2301 7th Avenue  
DRB Response - REC Meeting #2  
Date: February 11, 2020  
SDCI Project Number: 3034280-LU

This package is in response to DRB comments from the September 24th, 2019 REC meeting with the goal of addressing all the comments and concerns from that meeting. The specific DRB comments and applicant responses are summarized on pages 4 and 5. Subsequently, each specific DRB comment has a response through graphics and text.

## DRB Guidance - SDCI notes of 09/24/2019 Rec. Meeting

## Summary of Applicant Response to DRB Guidelines

**Departure Request 5**

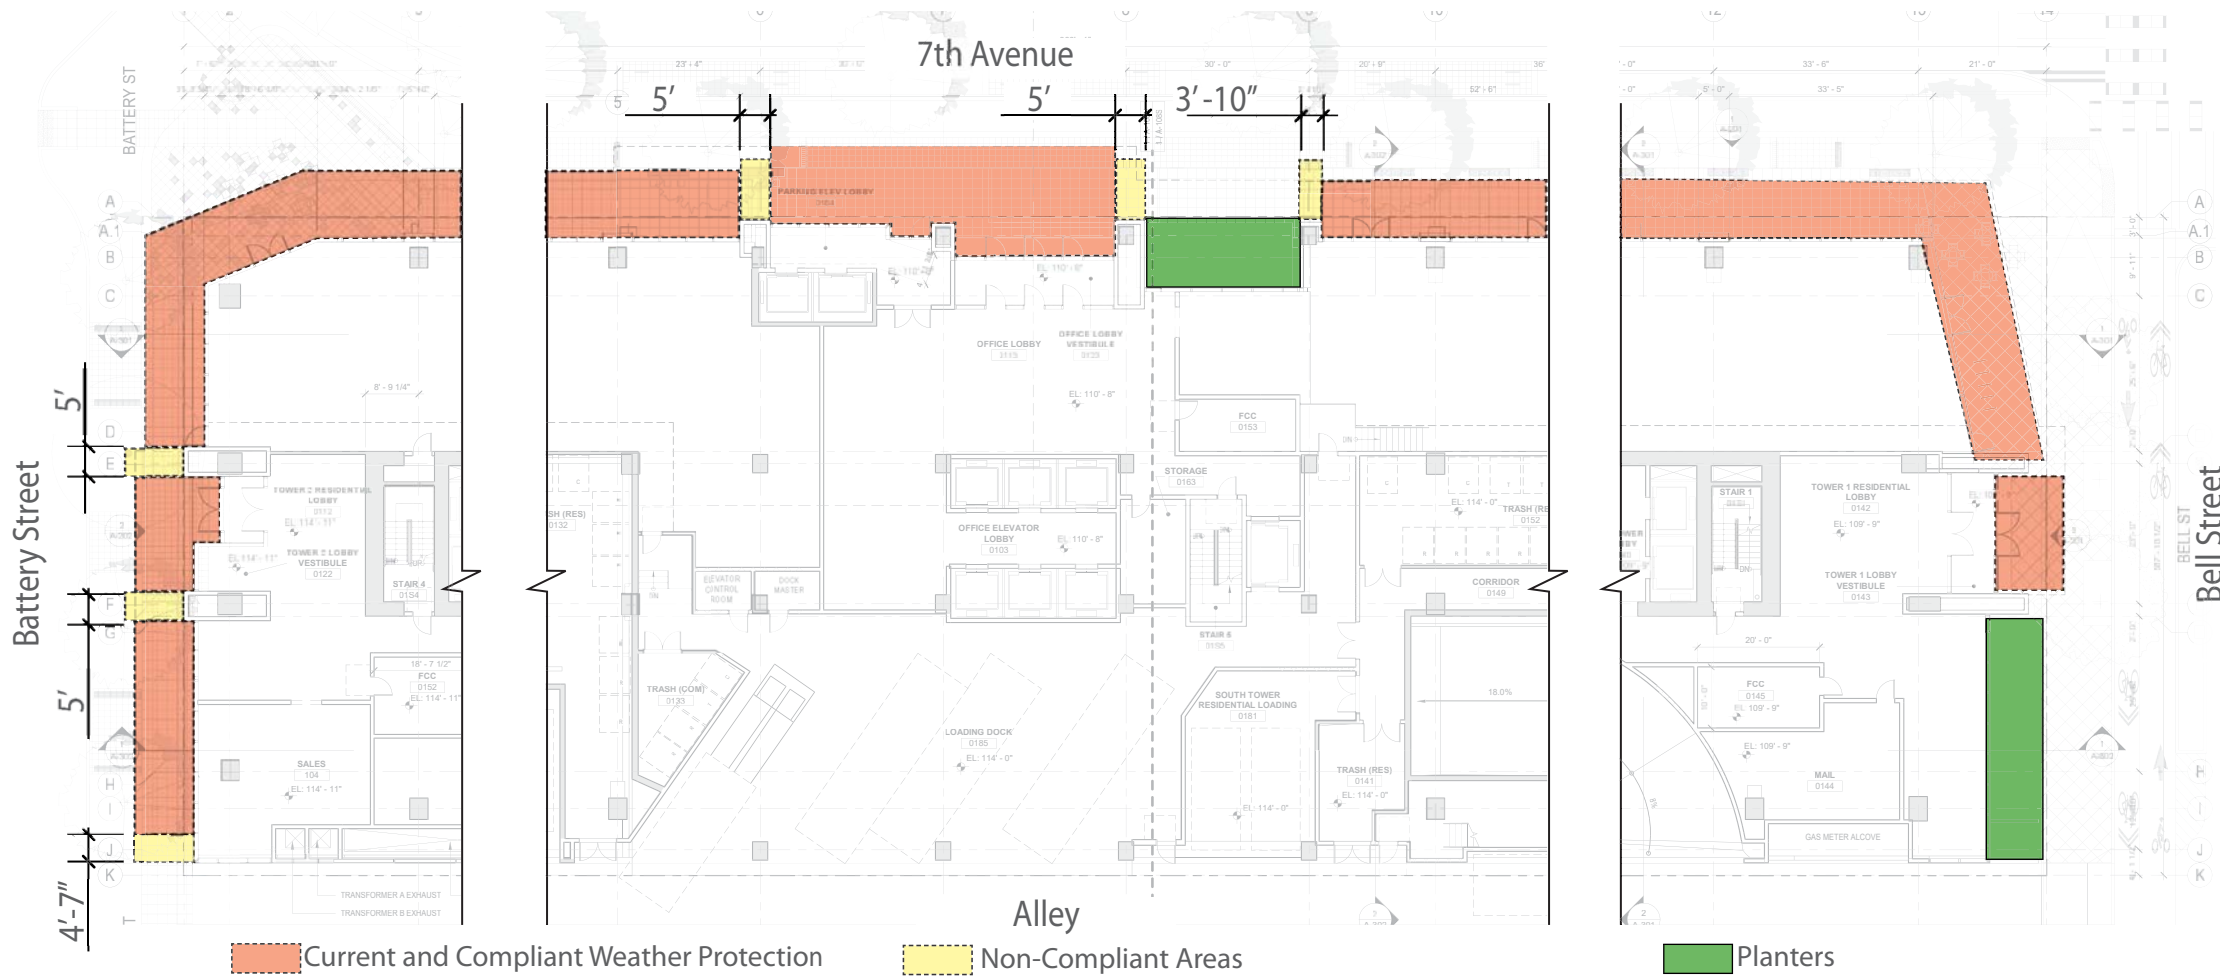
Per SMC 23.49.018, continuous overhead weather protection with a minimal horizontal dimension of 8', shall be required for new development along the entire street frontage of a lot unless certain criteria are met. Weather protections of the facades along Battery street and 7th Avenue are not continuous and are less than 8 feet in some areas. Please revise the plans to comply with this code section. Also provide dimension verifying the overhead weather protection is between 10-15 feet above the side walk.

We request a departure from the prescribed requirement of continuous overhead weather protection at the non-compliant locations shown. The project intends to emphasize the 3 main building entrances. (see Seattle Design Guideline C-4. "Reinforce Building Entries) To comply fully with the prescribed language noted in section 23.49.018, the clarity of the 3 main entries (Office, Bell Street and Battery Street Residential) will be compromised. The design strategy for these entries utilizes reoccurring components of large stone wall/pilasters, and flanking glass entry vestibules with solid metal canopies above. This is purposefully different than the typical retail canopy design of suspended glass from cut metal T's. Additionally, we request a departure setback at the Battery and alley corner as precaution against large vehicles entering and leaving the alley.
